CONTRACT CHANGE ORDER

CCO: 50 Suppl. No. 0 Contract No. 04 – 0120F4 Road SF-80-13.2/13.9 **FED. AID LOC.:**

Provide additional reinforcement to the shear plates at Hinge A as shown on sheets three (3) through six (6) of this change order.

SAN FRANCISCO OAKLAND BAY BRIDGE
EAST SPAN SEISMIC SAFETY PROJECT
SELF-ANCHORED SUSPENSION BRIDGE
(SUPERSTRUCTURE & TOWER)

TYPICAL GIRDER DETAILS NO. 7

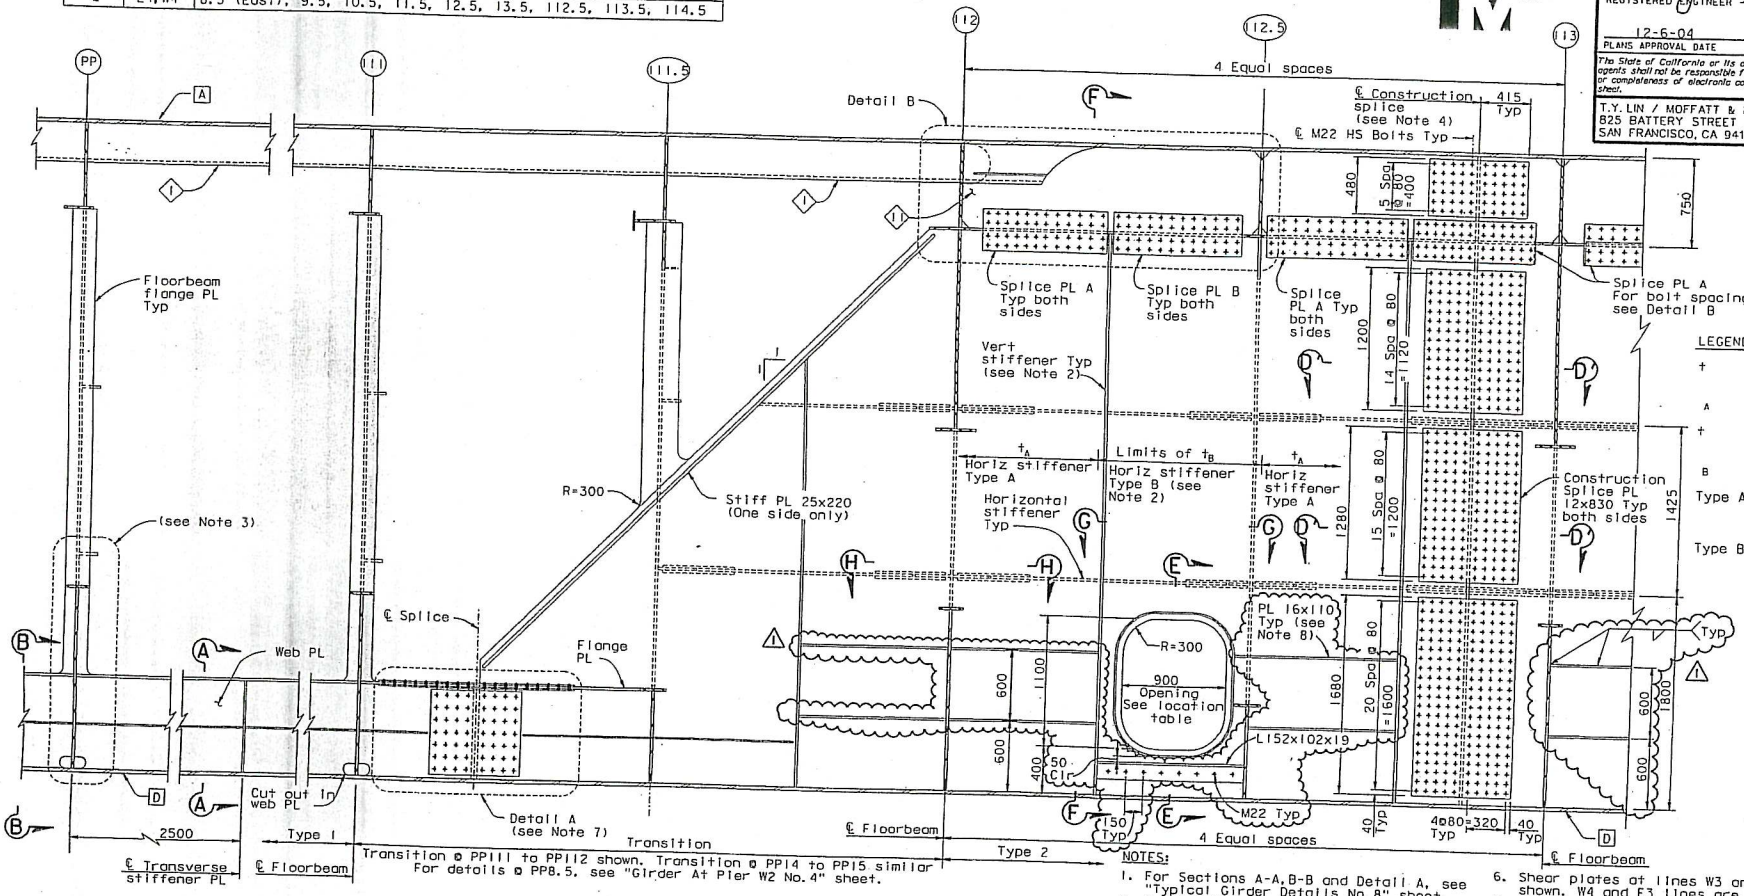
MARK	DATE	DESCRIPTIONS	BY	CH'D	CCO#
1	07/31/07	HINGE A REACTION-SHEAR PLATES	DT	GB	50

TYPICAL GIRDER DETAILS NO. 9

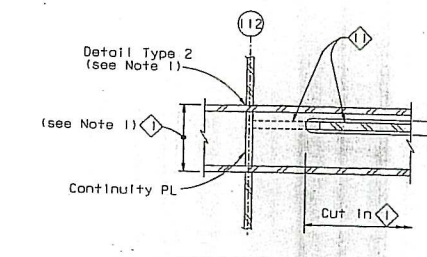
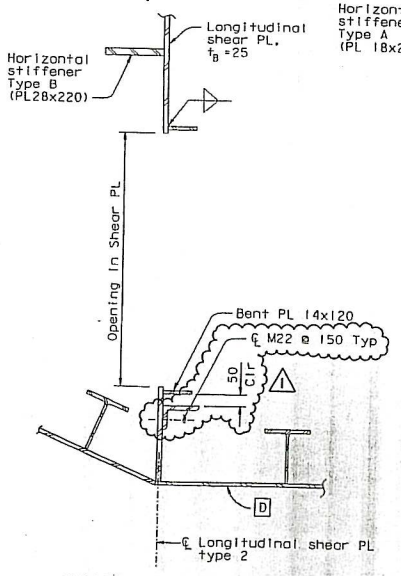
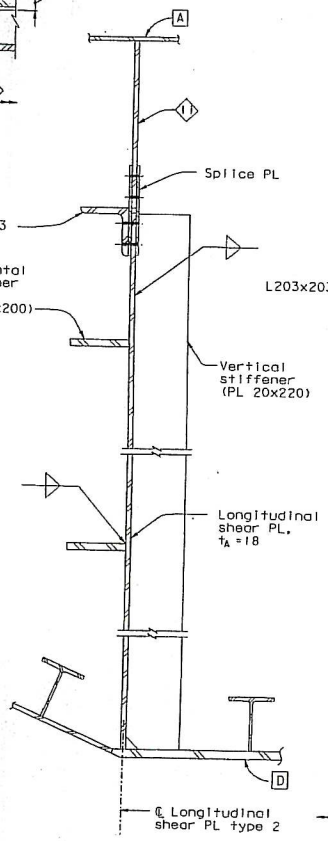
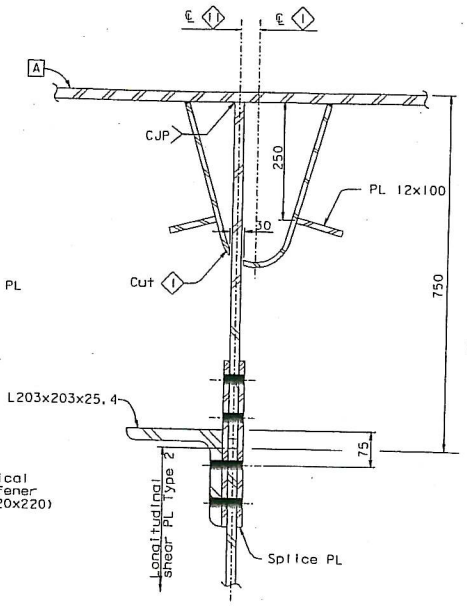
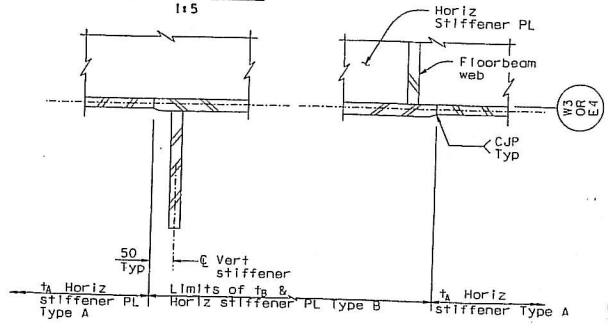
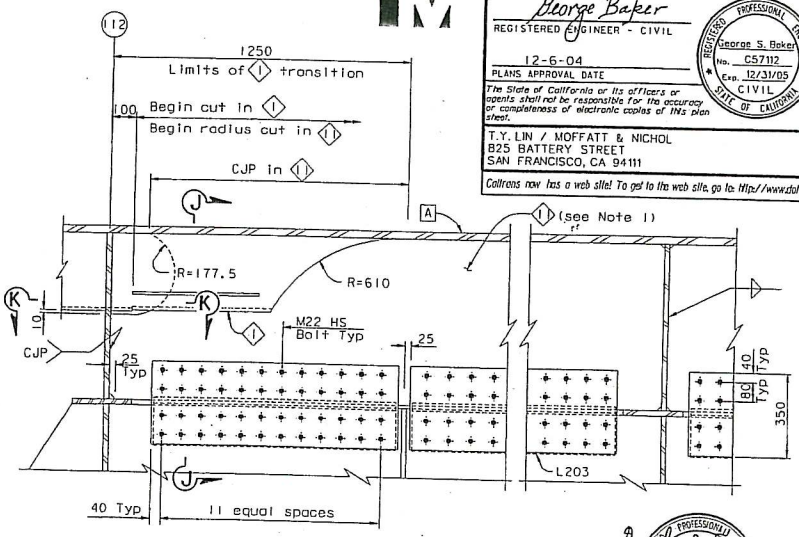
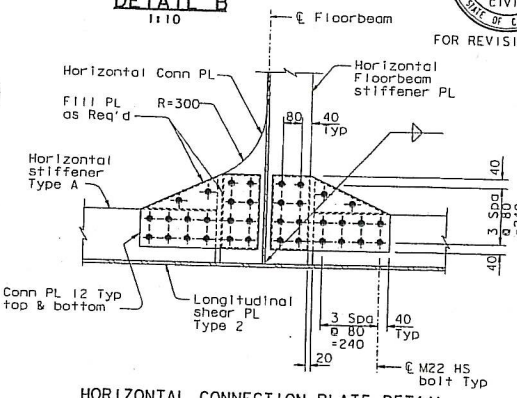
MARK	DATE	DESCRIPTIONS	BY	CH'D	CCO#
1	07/31/07	HINGE A REACTION-SHEAR PLATES	DT	GB	50

GIRDER AT PIER E2 NO. 2

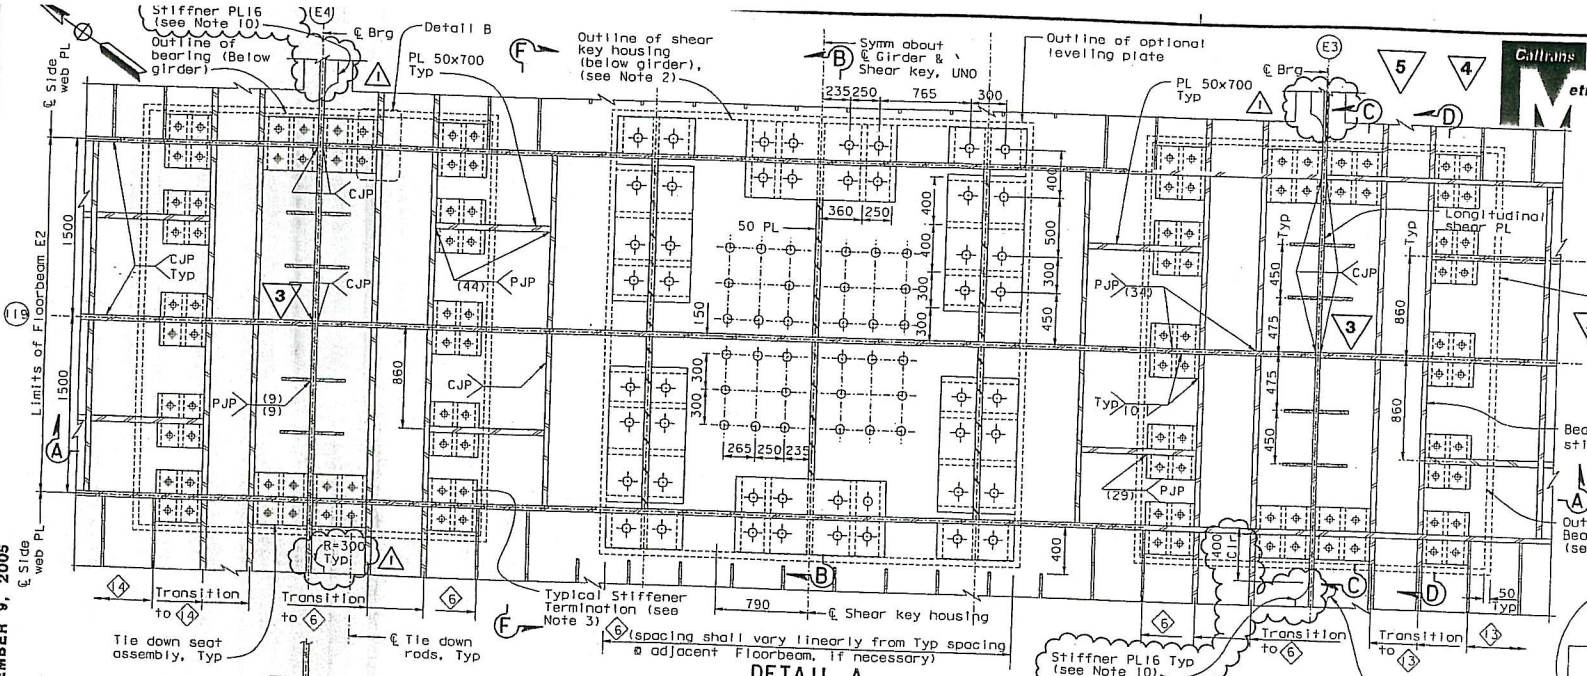
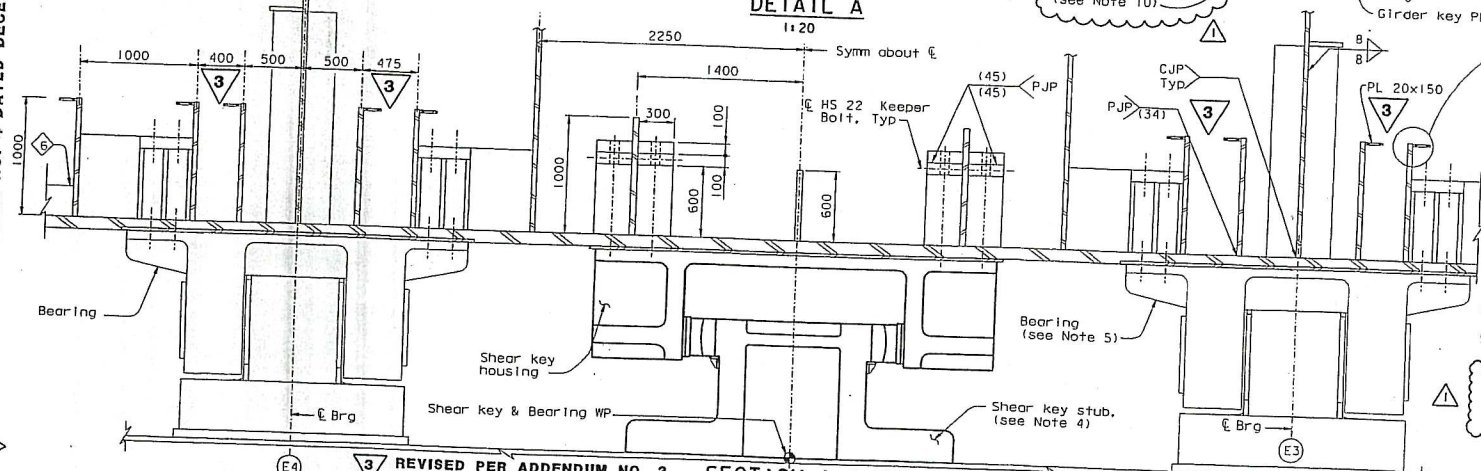
MARK	DATE	DESCRIPTIONS	BY	CH'D	CCO#
1	07/31/07	HINGE A REACTION-SHEAR PLATES	DT	GB	50

GIRDER AT EAST TRANSITION NO. 15

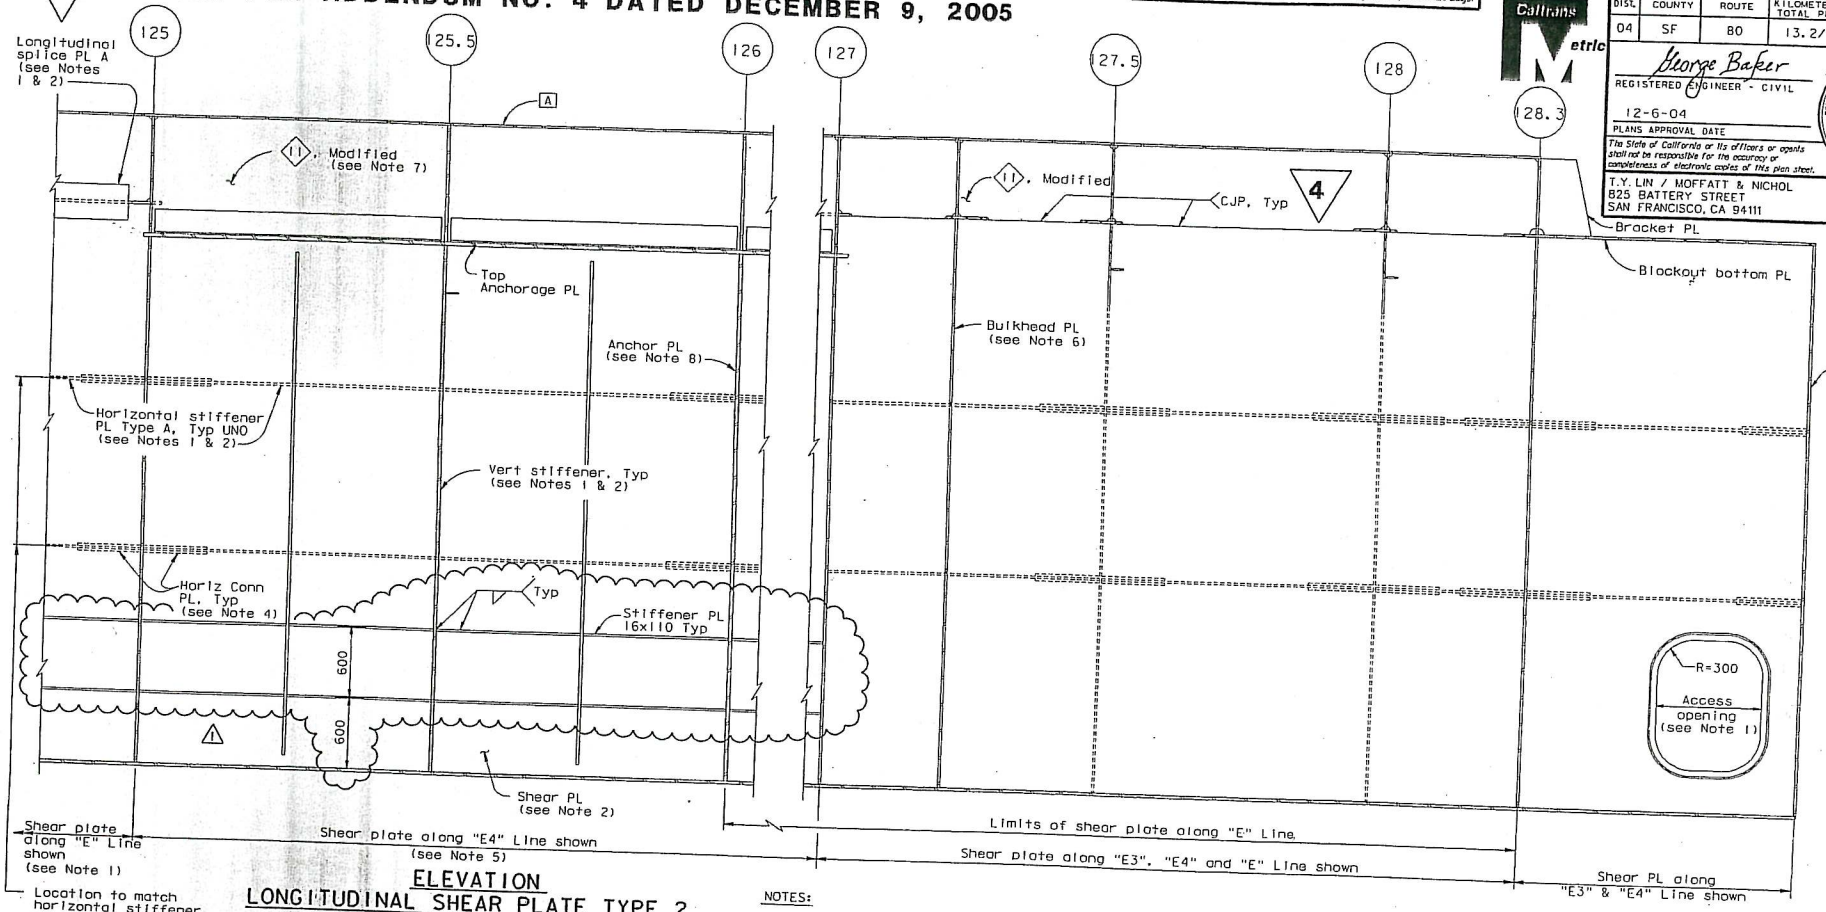
MARK	DATE	DESCRIPTIONS	BY	CH'D	CCO#
1	07/31/07	HINGE A REACTION-SHEAR PLATES	DT	GB	50
